Platform A1 - Booth area  
Previous comments are  
still valid, see following  
slides

Important: the 12 columns of the Spray Booth have been modified after change of the Scrubber technology by Renault-VAZ

Axes 5-6/014-015

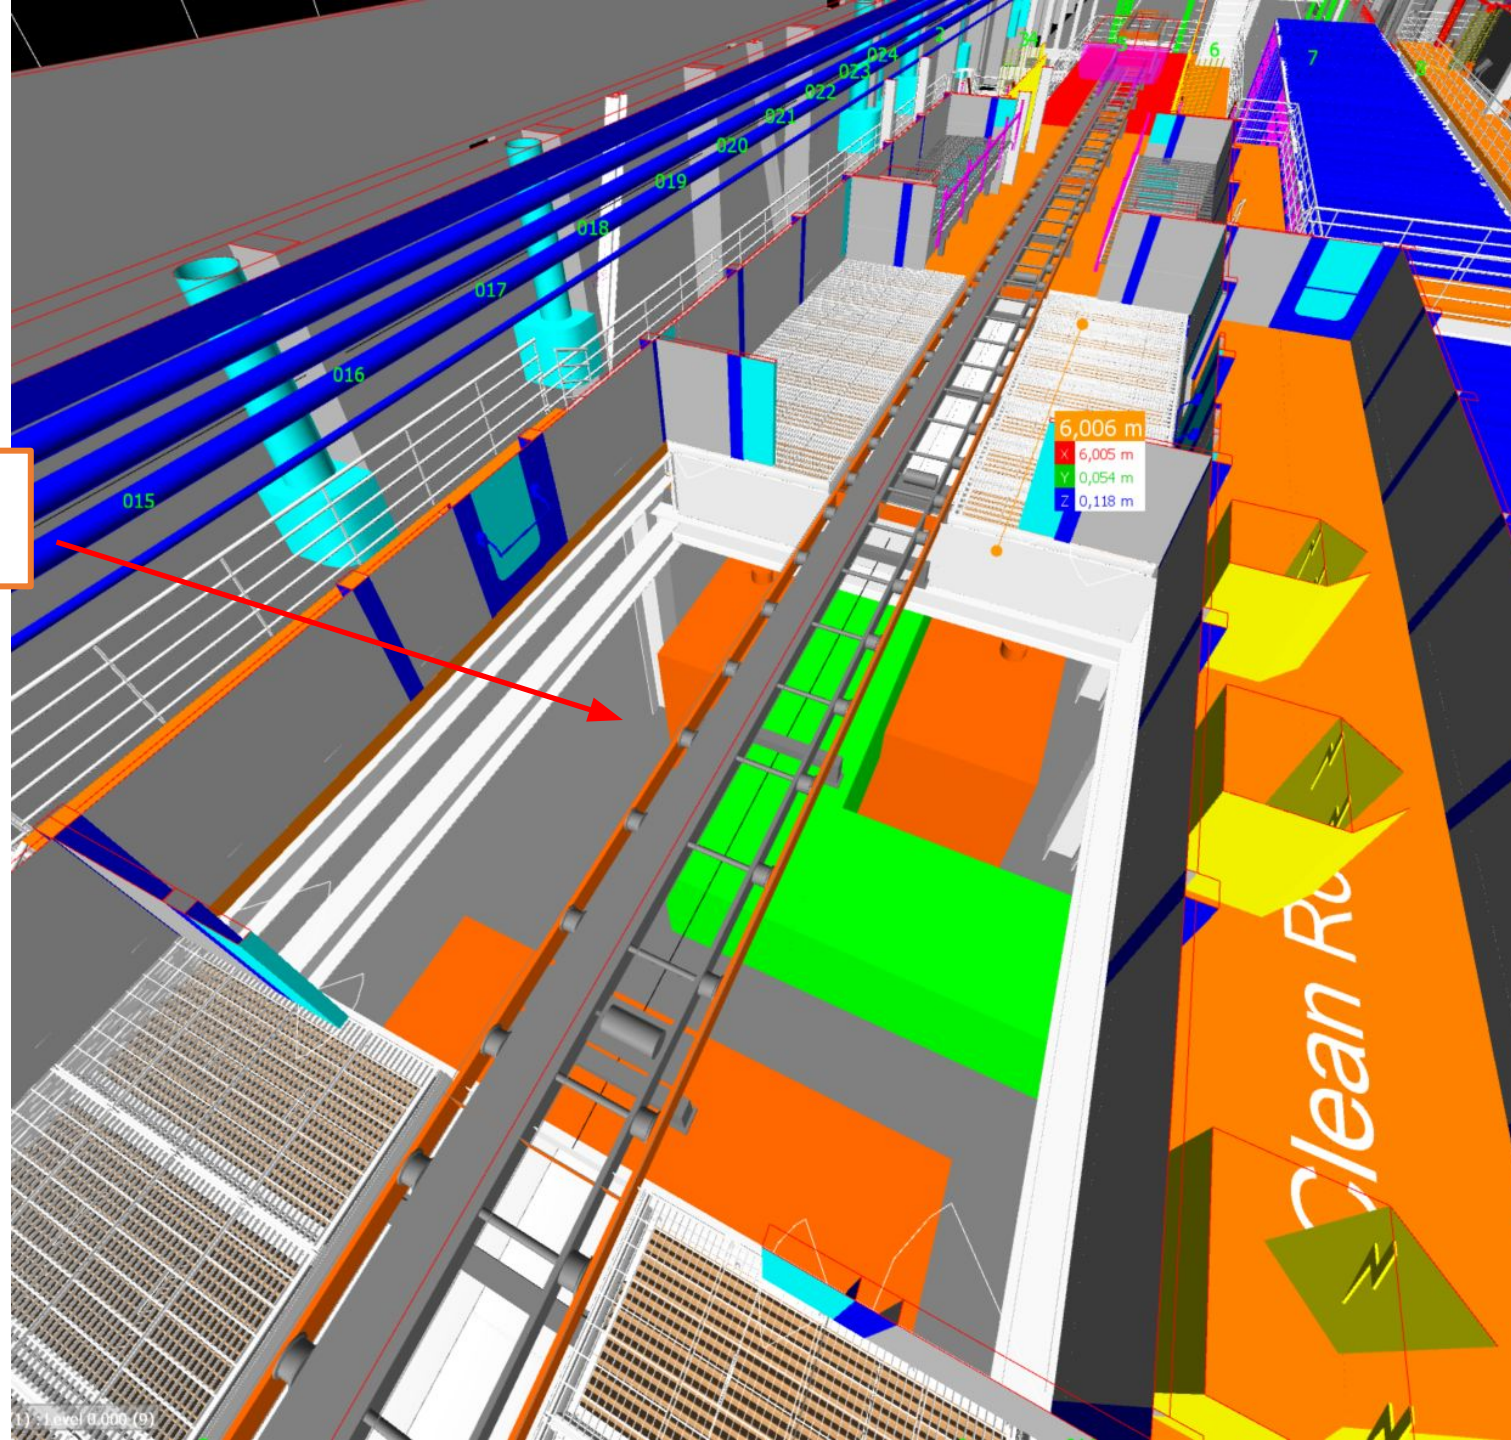
You forget the metal  
sheet and Omega Beam

Full metal sheet plate  
(t=5mm)

As you will see from our Booth layout & sections, the omega's purpose is to place the conveyor roller-bed; Please check correct dimensions and elevation of the Omega steel profile in section H on drawing E540350033\_D10\_A

Axes 5-6/014-015

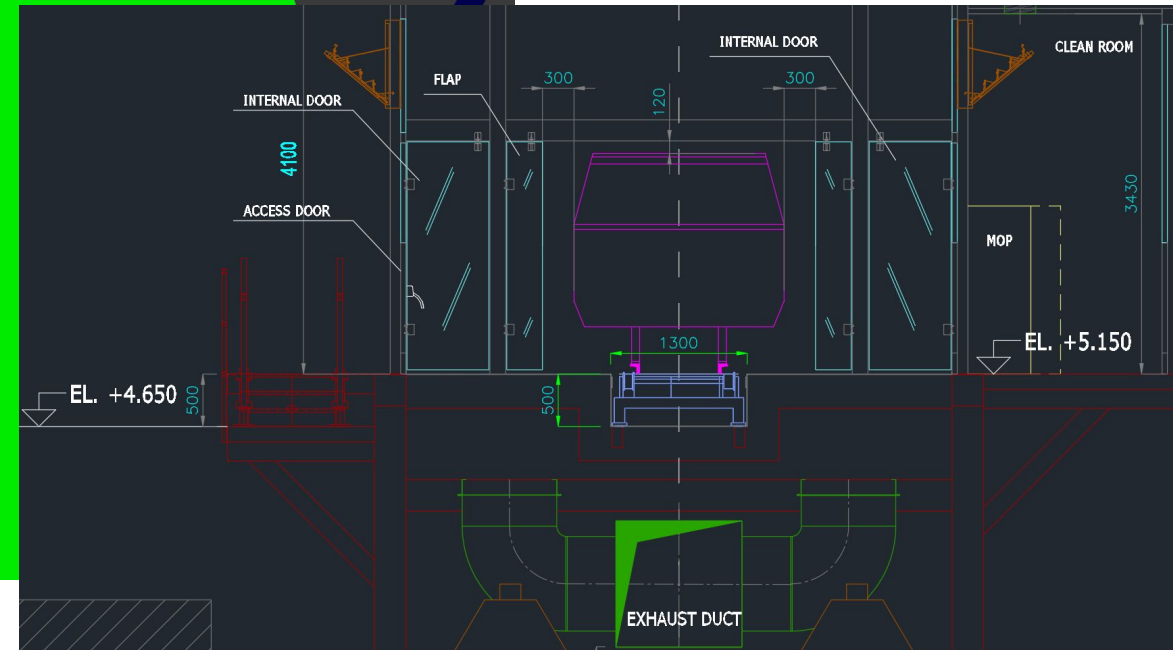
Side full metal sheet plate (non structural) only for gaps flashing (t=2÷3mm)

In Base coat and Clear coat zones we have lowered beams because we'll need to locate the **Drypan scrubber** (basically a big duct with filters) and the conveyor Roller-bed.

Axes 5-6/015-016

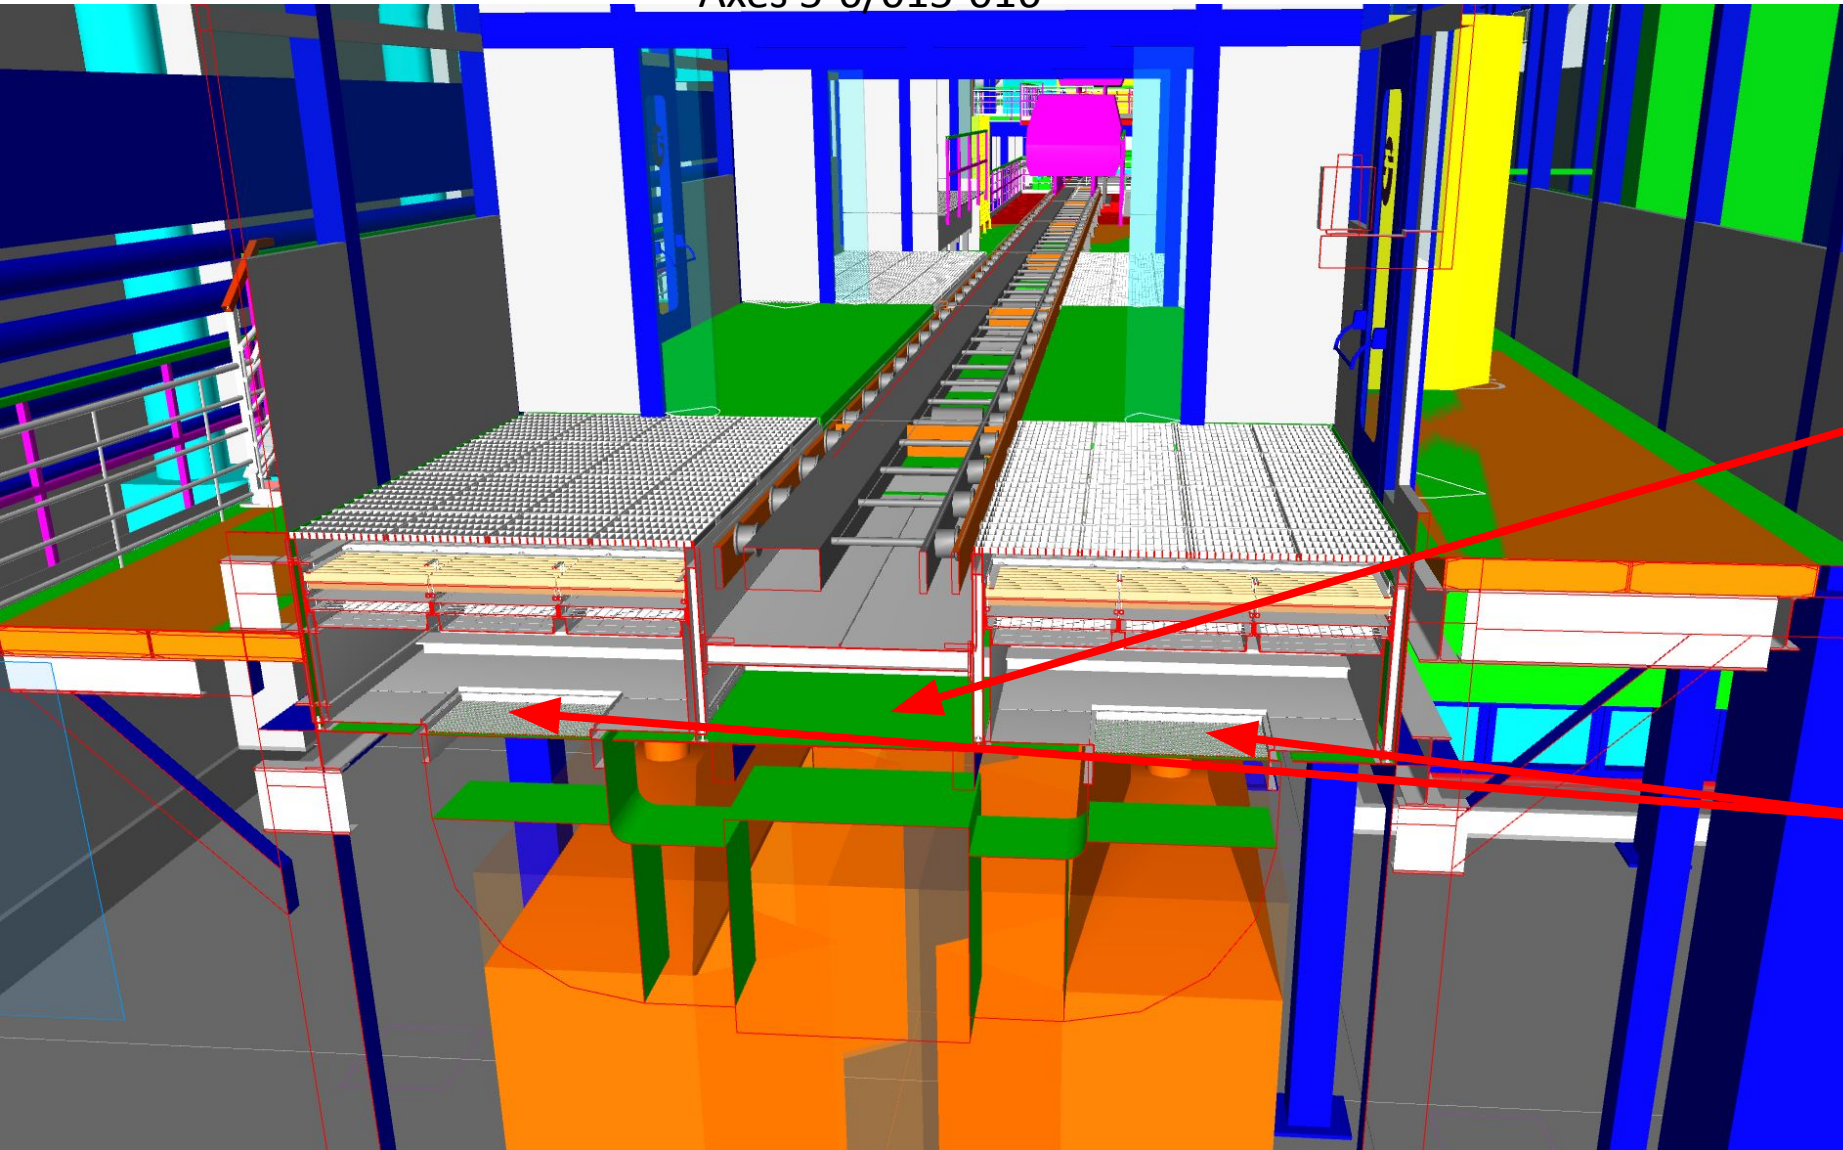
Please check our drawings (Booth layouts & sections, Drypan scrubber) for beams elevation; Basically in these zones the TOP of the cross beams shall be at -505mm from level 4,65m = 4,145m

The bottom of this «tank» will have to be covered by full metal sheet plate (t=5mm)

The tank floor will have to foresee two holes 950x950mm (one per side) for Extraction ducts, see layouts for location

Axes 7/013-014

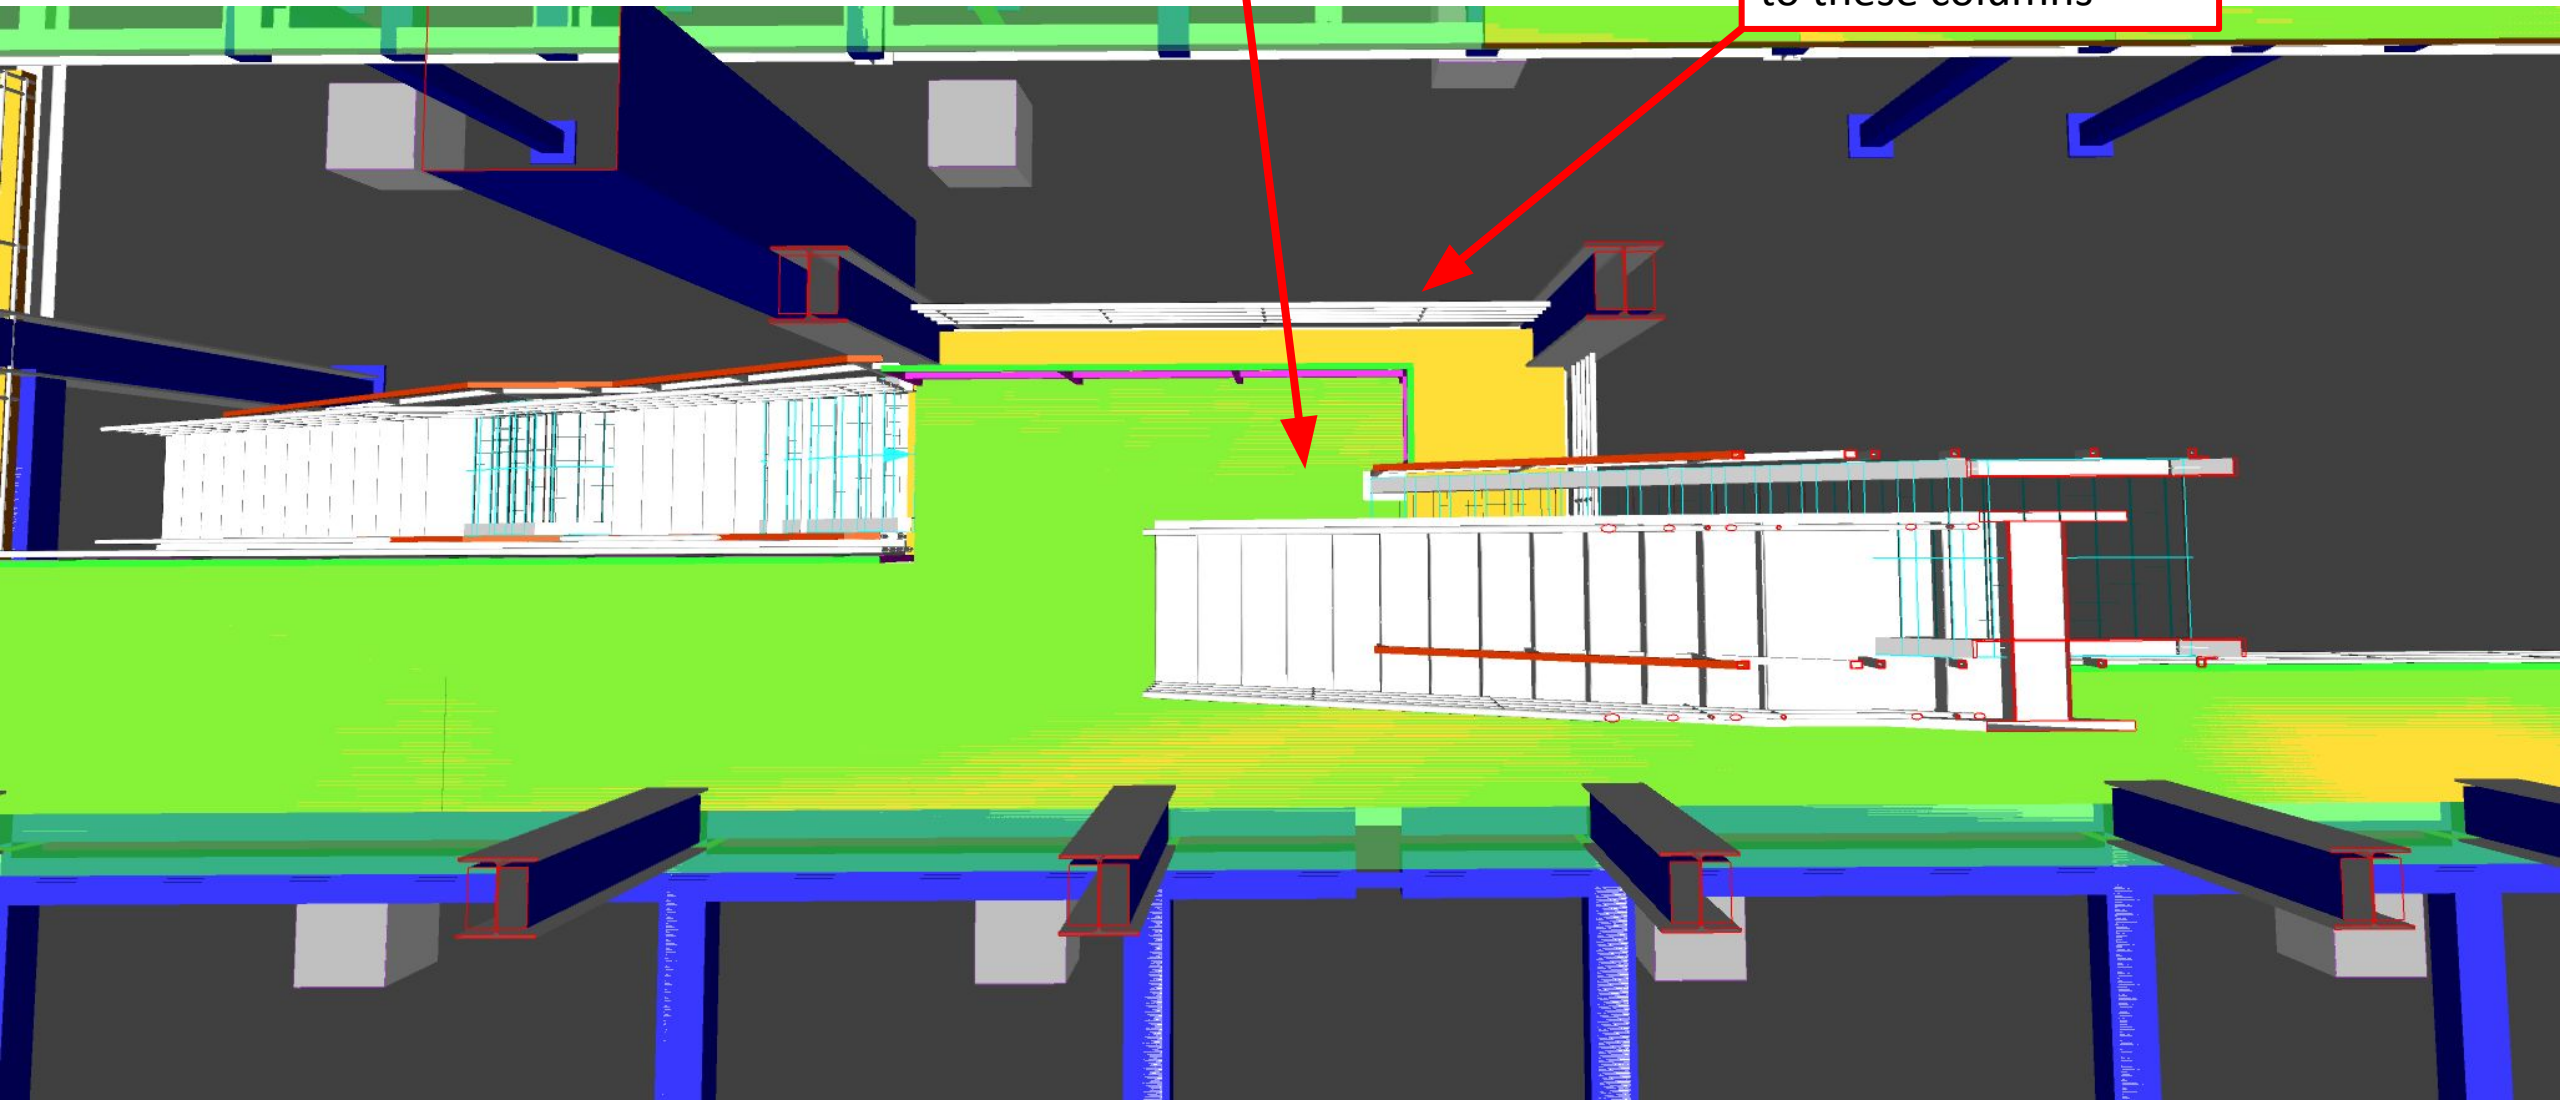
In this zone the stair that goes on 9,80m level is not aligned to ours

OK to extend platform to these columns

Axes 5/012

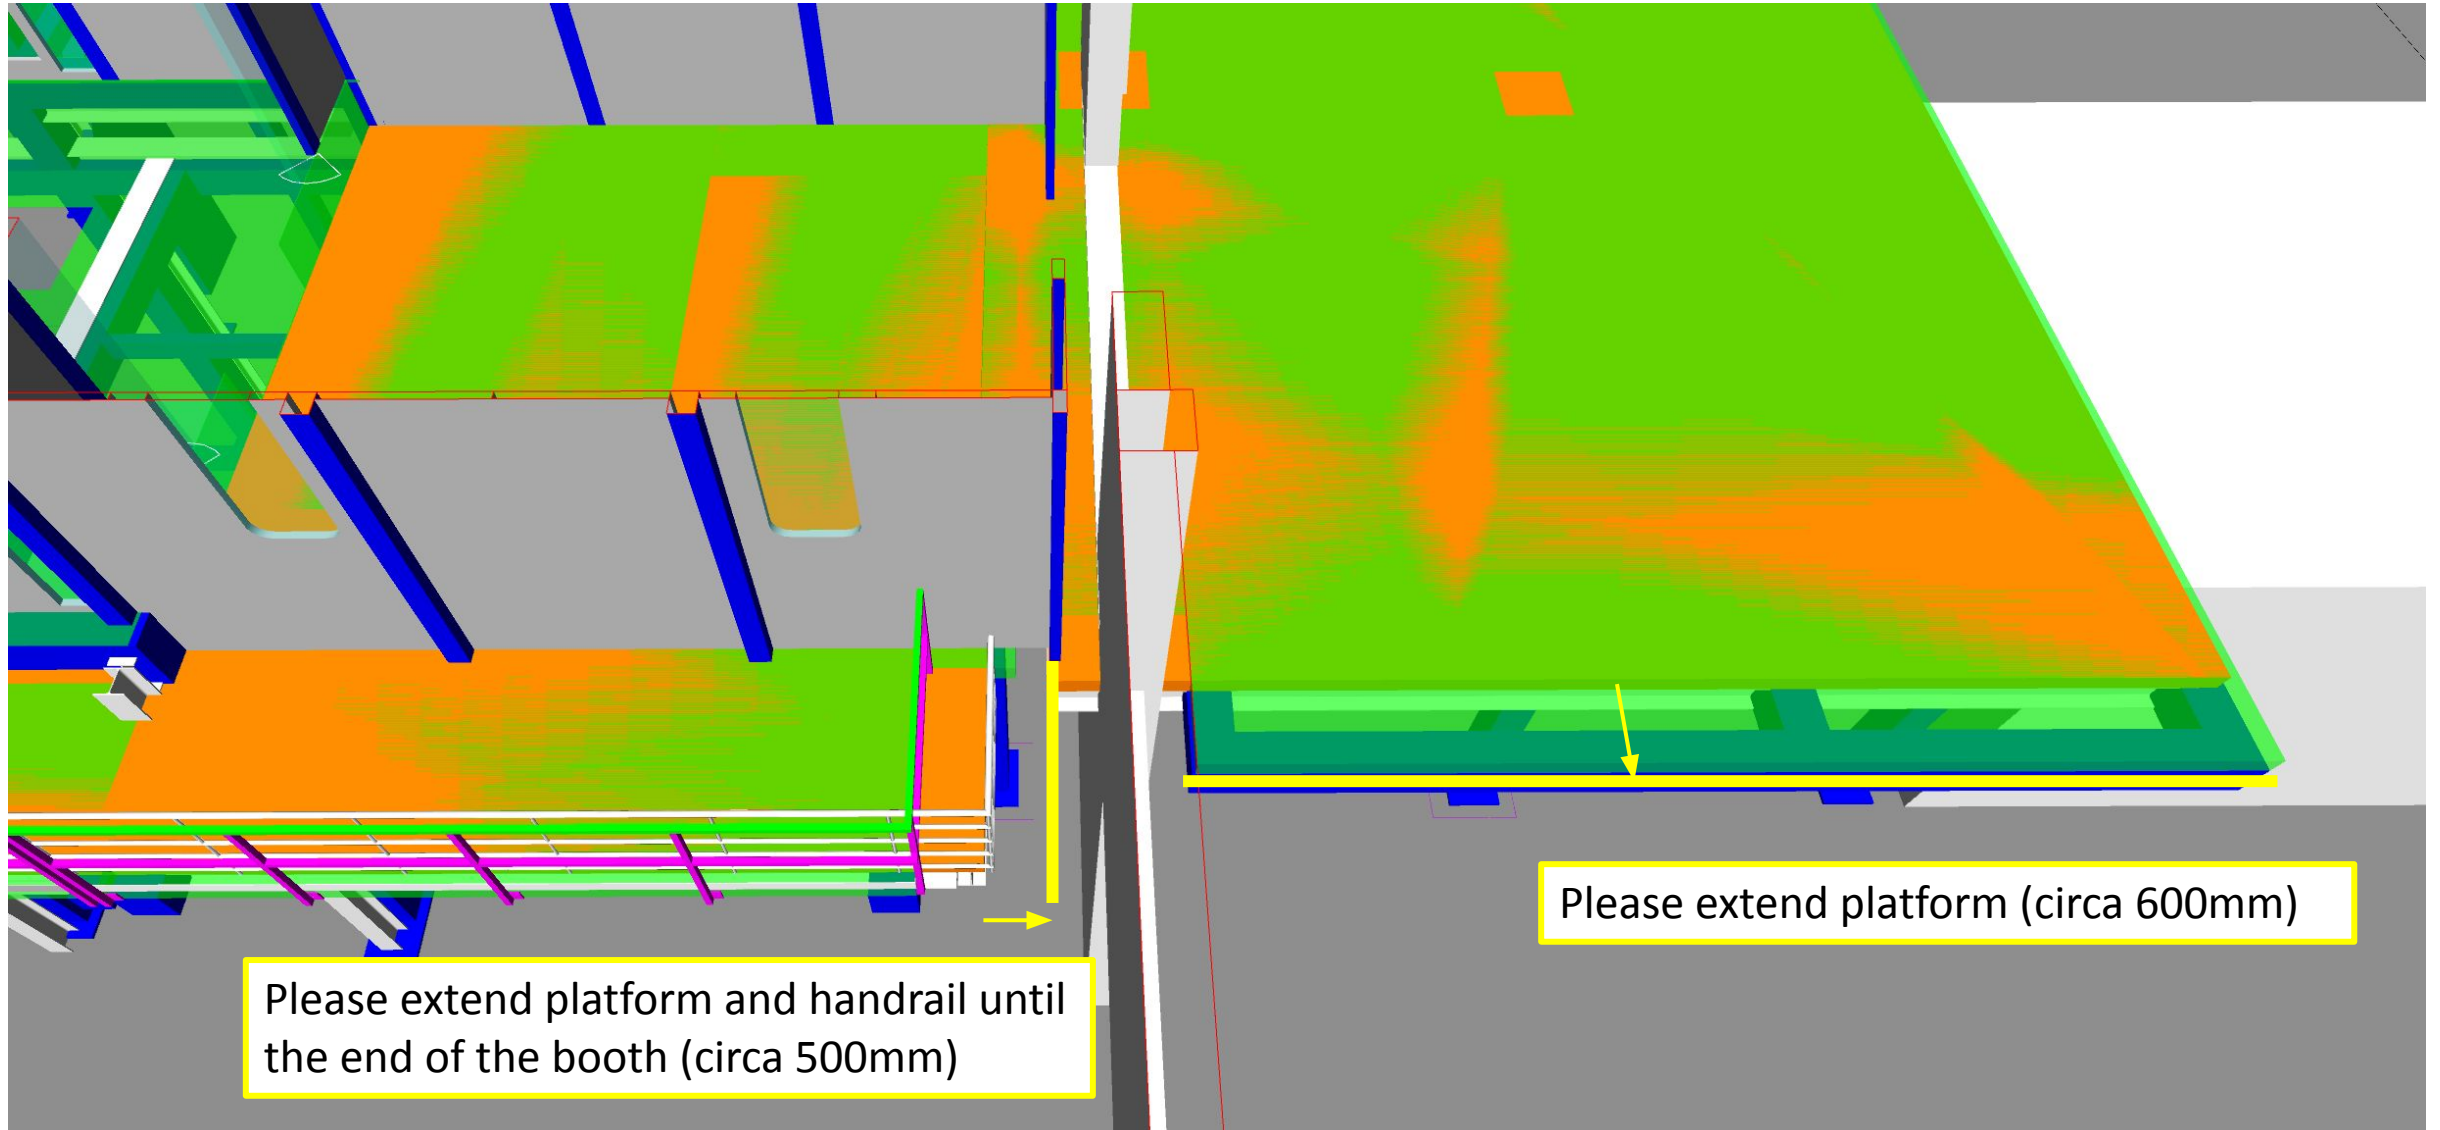
Please extend platform and handrail until the end of the booth (circa 500mm)

Please extend platform (circa 600mm)
